MFN 10-089 Revision 2

Docket No. 52-010

Subject: **Revised Response #2 to NRC RAI Letter No. 409 Related to ESBWR Design Certification Application – DCD Tier 2 Section 10.2 – Steam and Power Conversion System; RAI Number 10.2-18 S03**

Figure 10.4-7a. High Pressure Extraction Steam System

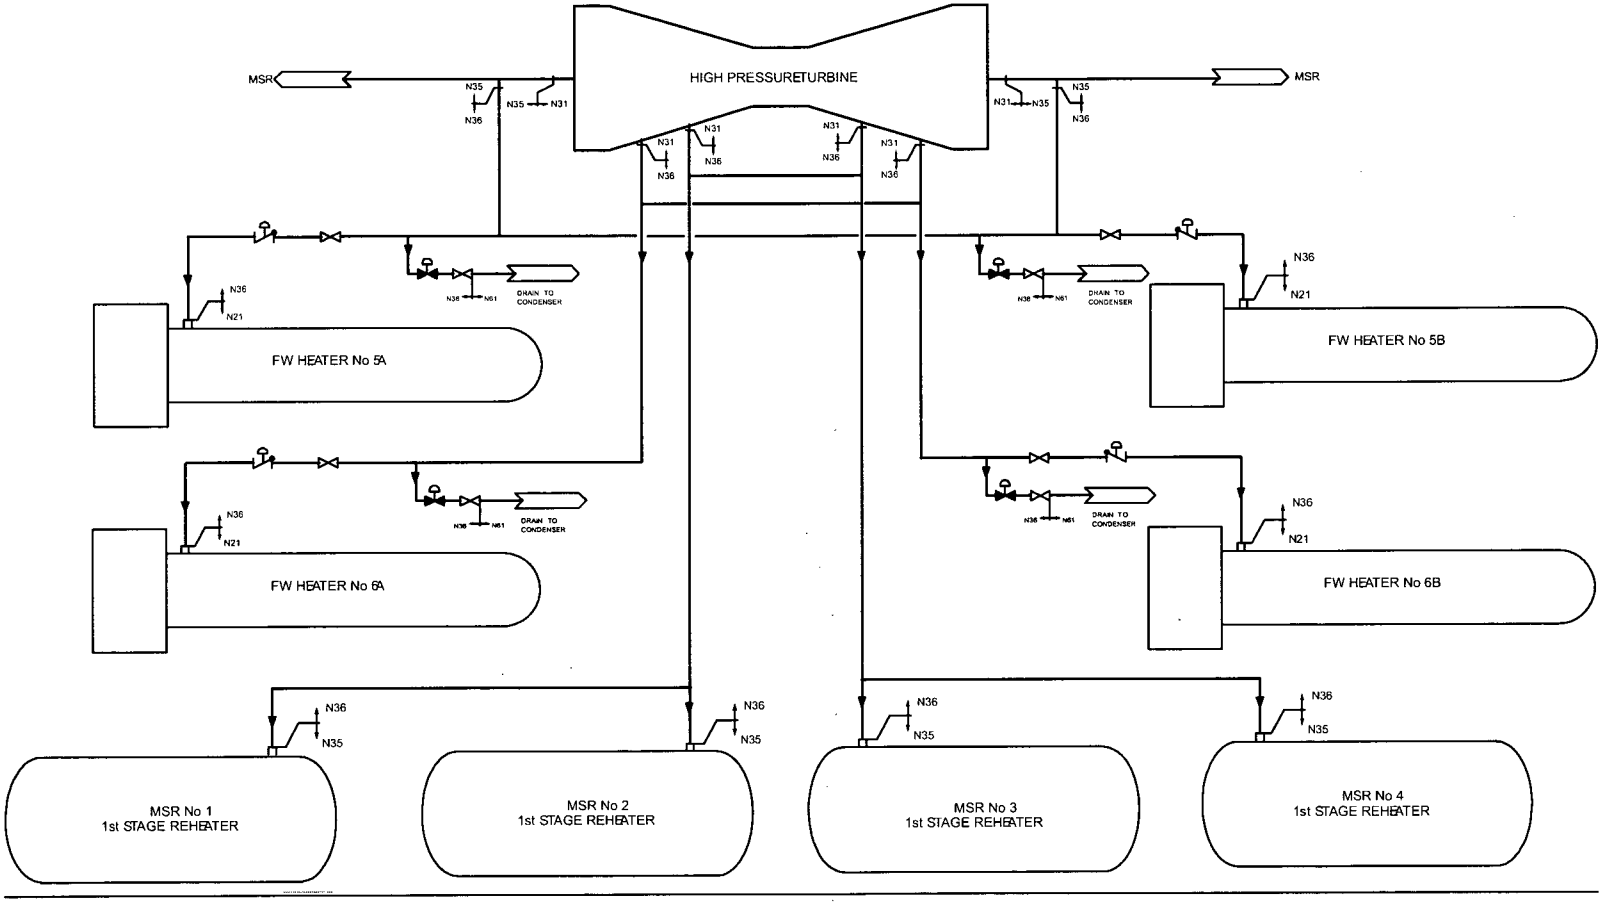
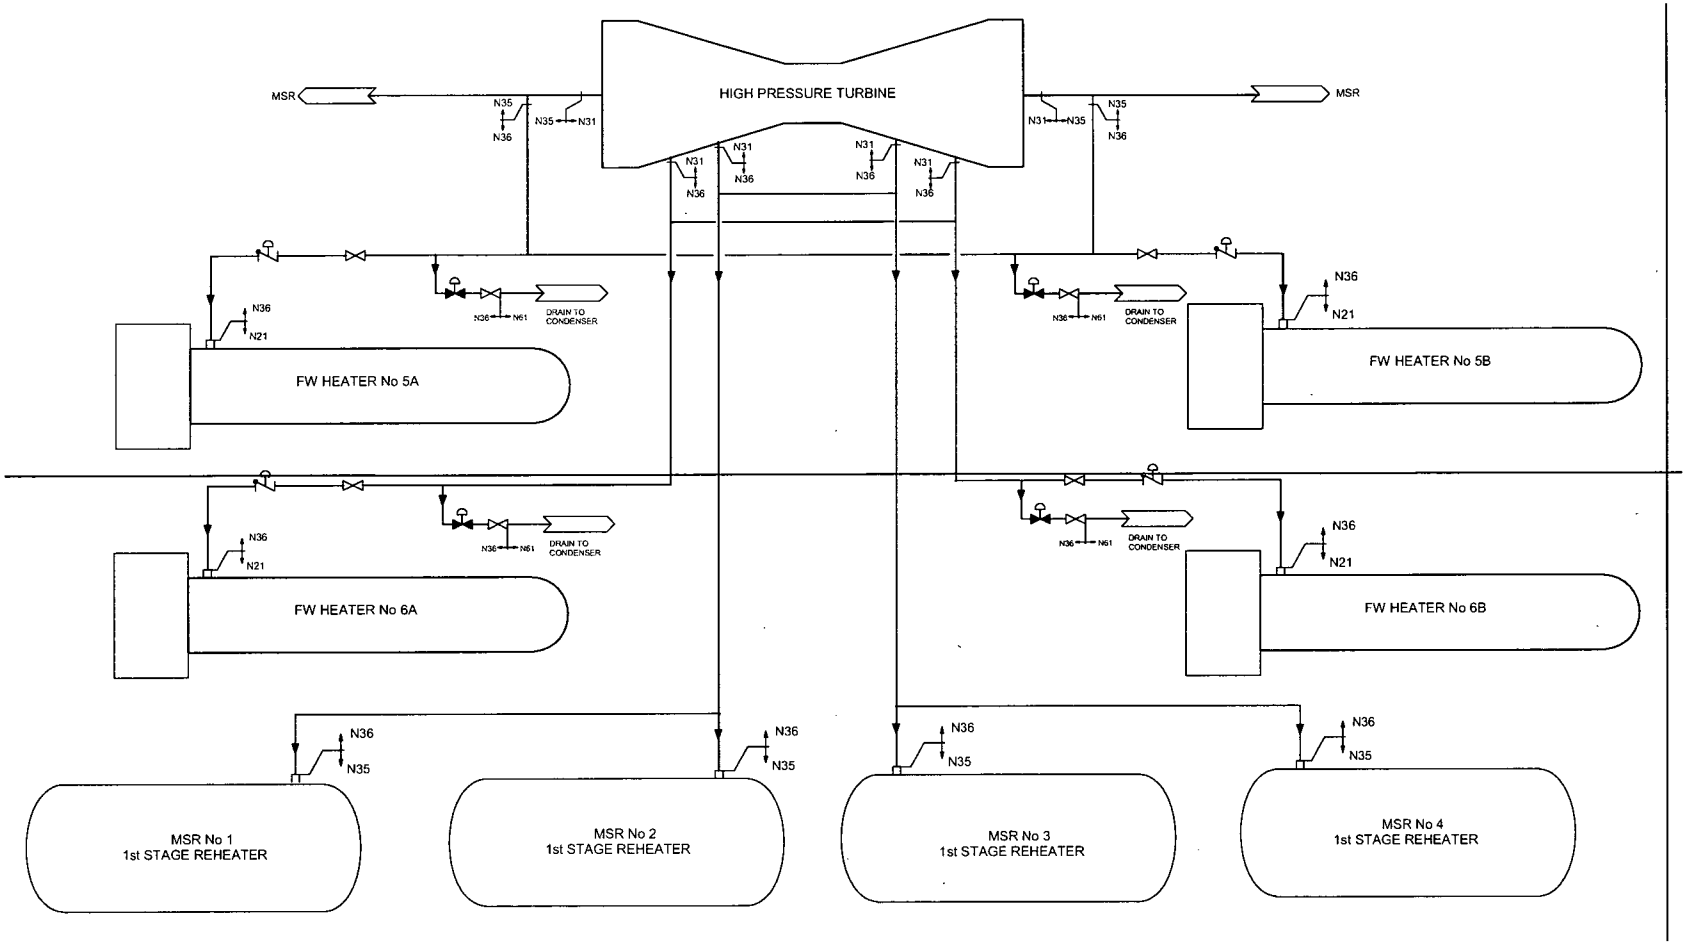
GEH has provided inconsistent information concerning where non-return valves are located and to what extent they are needed in order to prevent the turbine from exceeding 120% rated speed, including consideration of single failures. [NRC] current understanding based on the most recent information that was provided is that both power assisted and simple non-return check valves need to be credited to prevent the turbine from exceeding 120% rated speed during a loss of load event. The proposed revision in the February 28 e-mail response provides an acceptable description. However, the Tier 1 functional diagram needs to be revised to include simple non-return check valves that are needed to prevent the turbine from exceeding 120% rated speed.

DCD Figure 10.4-7a also shows locations where spring assisted extraction steam non-return valves are required on the high-pressure heaters. DCD Figure 10.4-7a was revised to correct the orientation of the spring assisted non-return valves on the 5A and 6A feedwater heaters, they were shown backwards in earlier revisions of the DCD.

Figure 2.11.1-3. Extraction Steam Functional Arrangement

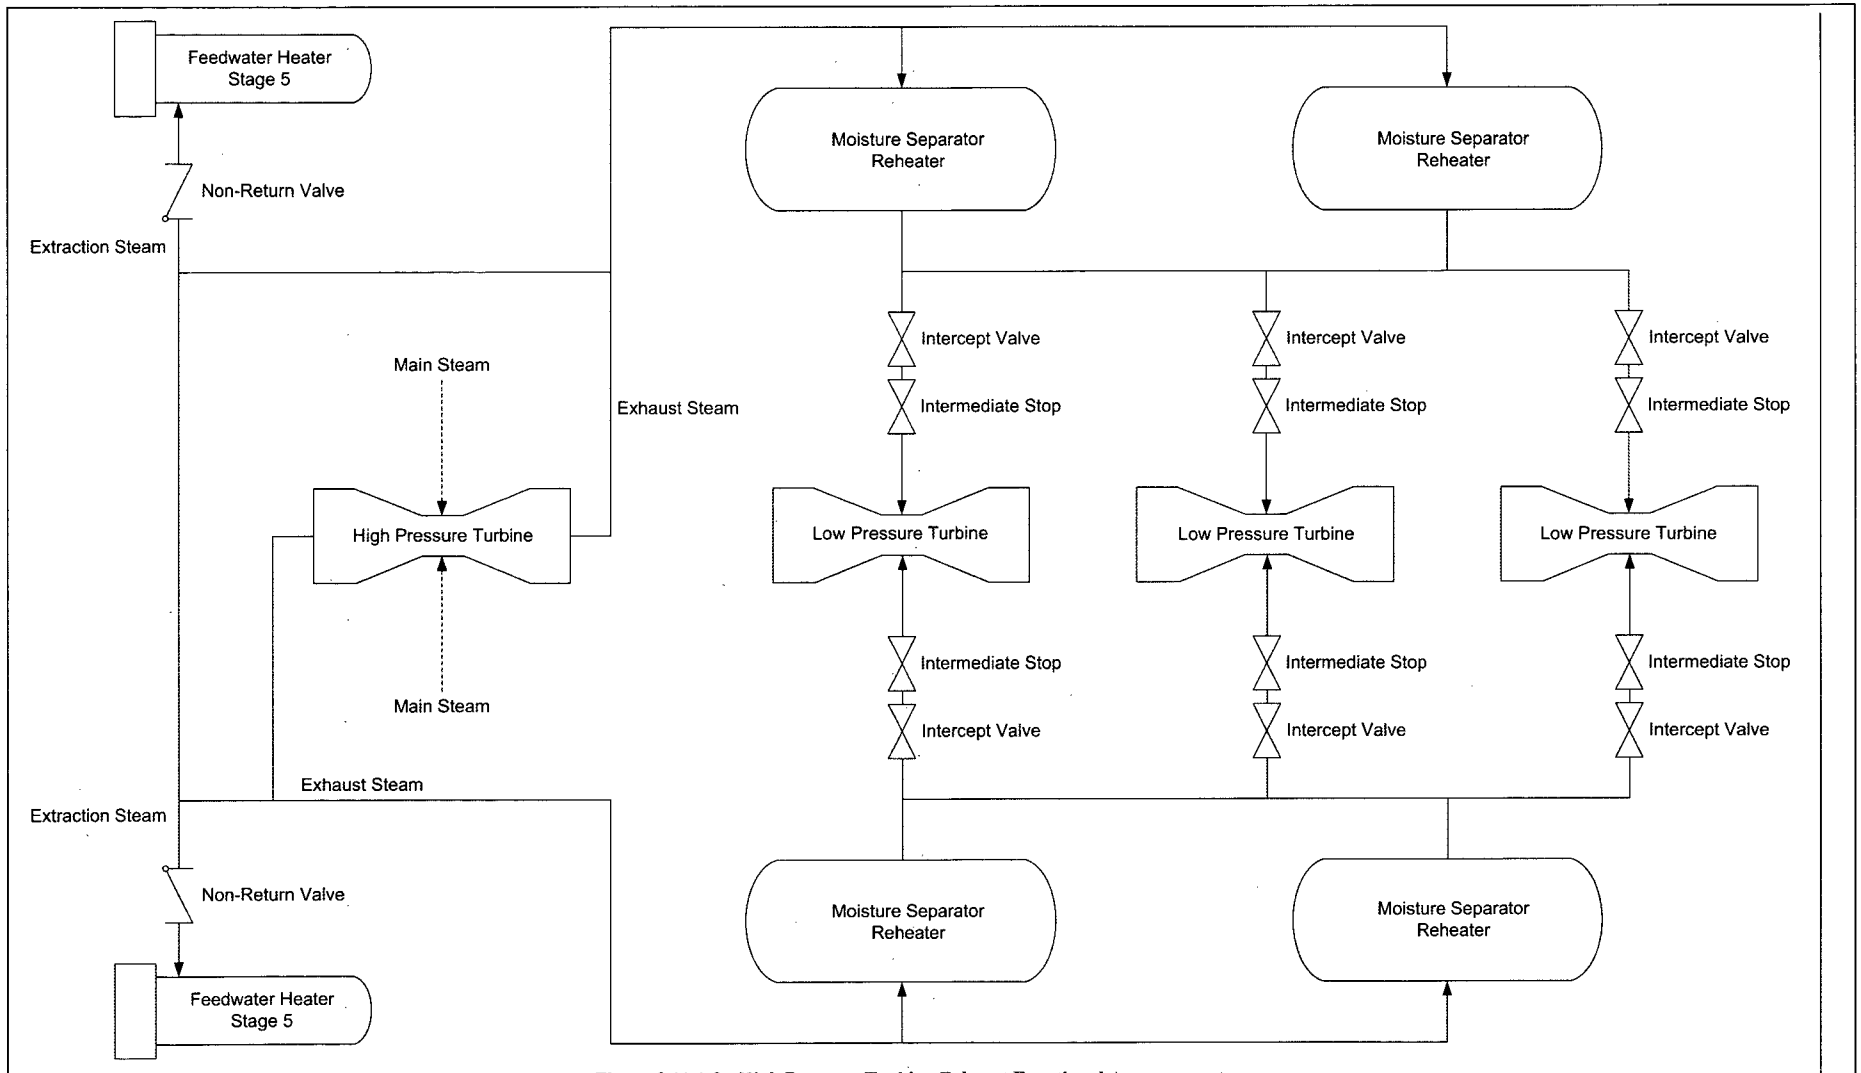
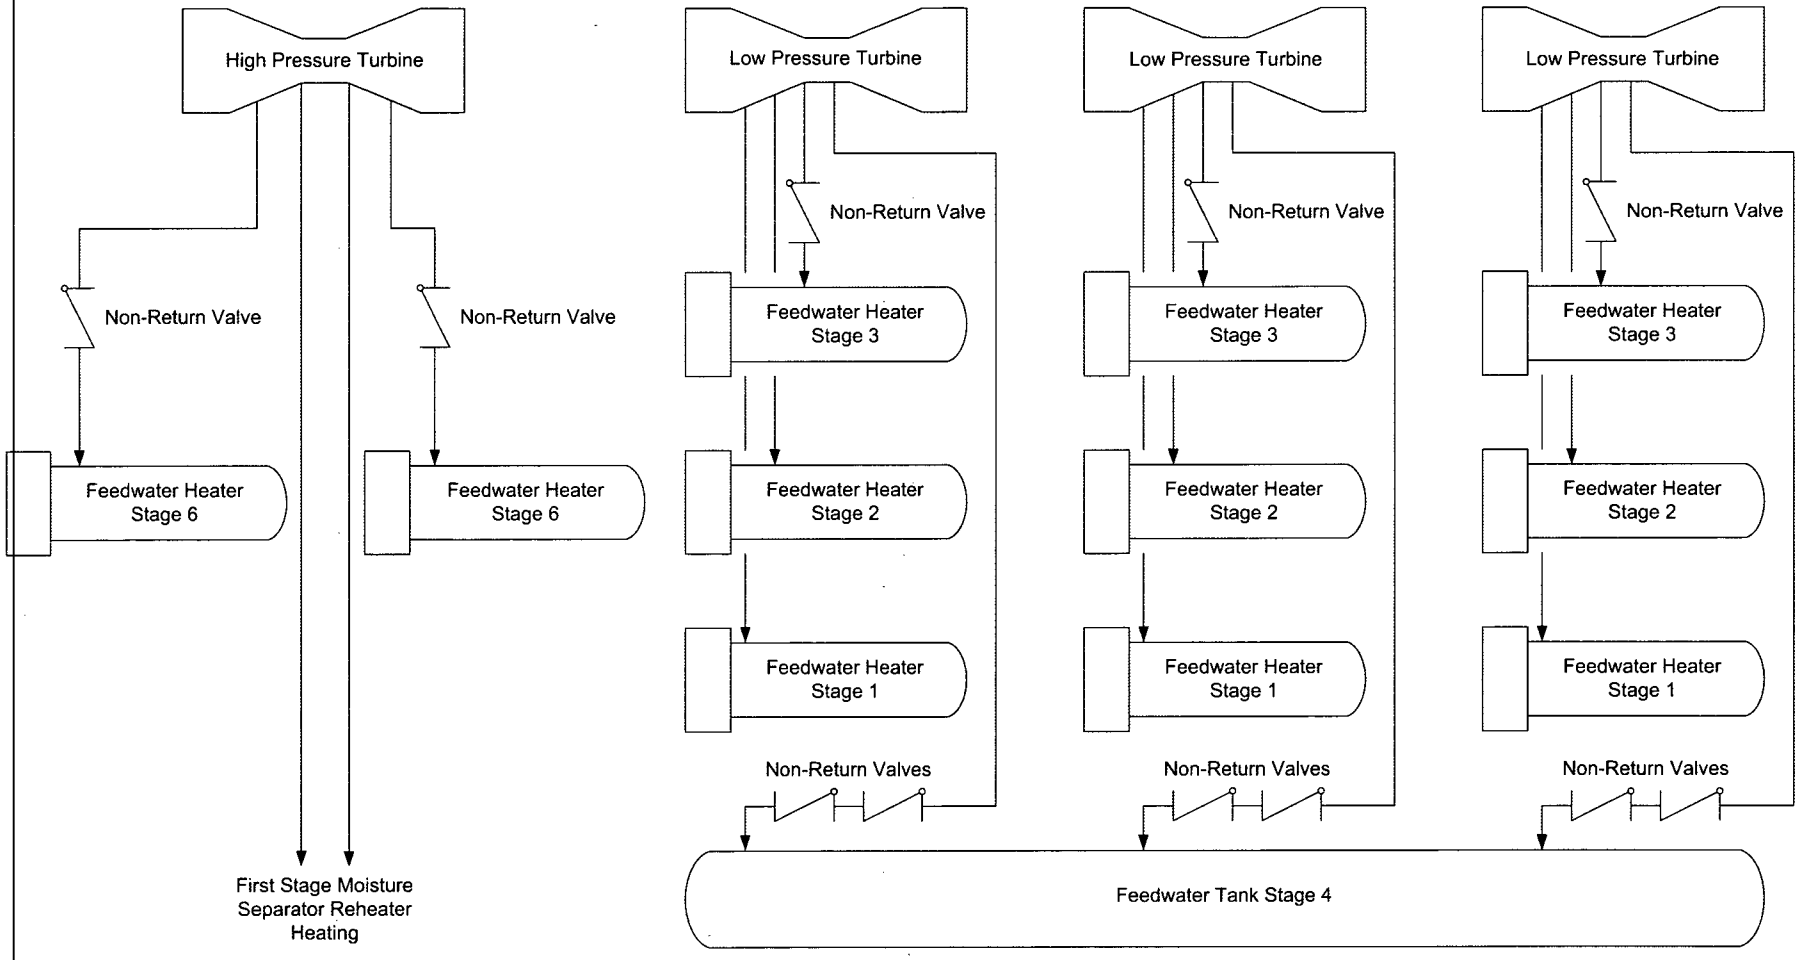
12) An ITAAC is needed to verify the layout/locations of turbine stop, control, intermediate stop, intercept, and extraction non-return valves.

DCD Tier 1 Subsection 2.11.1 covers the proposed DCD Tier 1 design description, Table 2.11.1-1 and Figure 2.11.1-1, -2, and –3 diagrams that verify the layout/locations of turbine stop, control, intermediate stop, intercept, and spring assisted extraction non-return valves. The DCD Figure 2.11.1-2 has the exhaust steam and extraction steam lines labeled to preclude confusion on location. Simple check type non-return valves installed on extraction lines are not required to be shown in the DCD or Tier 1 since they do not have a function in turbine overspeed protection.

Enclosure 2 has the proposed DCD Tier 1 descriptions, Table and Figures 2.11.1-1, -2, and –3 to verify the layout/locations of turbine stop, control, intermediate stop, intercept, and spring assisted extraction non-return valves.
